## Product Change Notice (PCN)

**PCN Number:** PCN-0451152R-01

**Product(s) Affected:** PJ-038A, PJ-038B, PJ-038AH, PJ-038BH

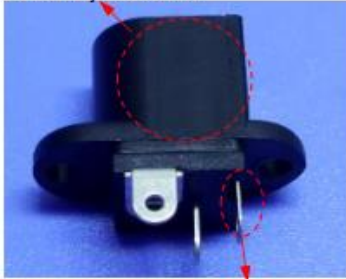
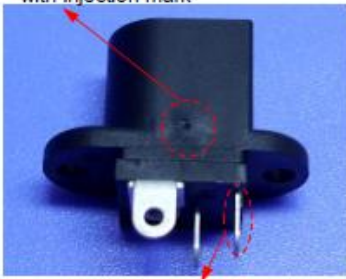
**Description of Change:** Thickness of pin 2 changed from 0.2mm to 0.25mm. Aesthetic changes as shown in below comparisons:

Current version	New version
Outlook		
Front	<p>without chamfer</p> 	<p>with chamfer</p>

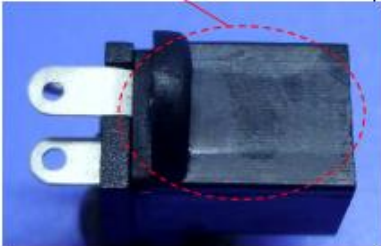
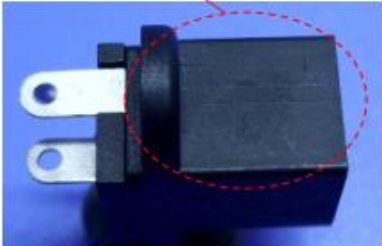
Back	<p>cave marking location</p>  <p>cave marking location</p>	<p>cave marking location</p>  <p>cave marking location</p>
Top	<p>without injection mark</p>  <p>thickness of pin#2 is 0.2mm</p>	<p>with injection mark</p>  <p>thickness of pin#2 is 0.25mm</p>
Bottom	<p>rough surface</p>  <p>with injection mark</p>	<p>smooth surface</p>  <p>with injection mark</p>
